# RENESAS TECHNICAL UPDATE

Product Category	MPU/MCU	Document No.	TN-RH8-B0468A/E	Rev.	1.00
Title	RH850 TSG3 issue		Information Category	Technical Notification	
Applicable Product	RH850 series	Lot No.	Reference Document	See related documents below.	
		All lot

The limitations of TSG3 are added as follows:

2. **Judgement flow**

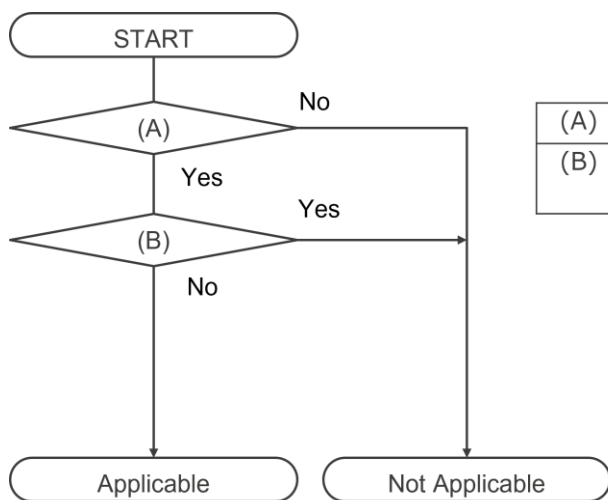
(A)	Using TSG3 ?
(B)	TSG3nATxx register bits should be set when the timer is stopped (TSG3nSTR0.TSG3nTE = 0) ?
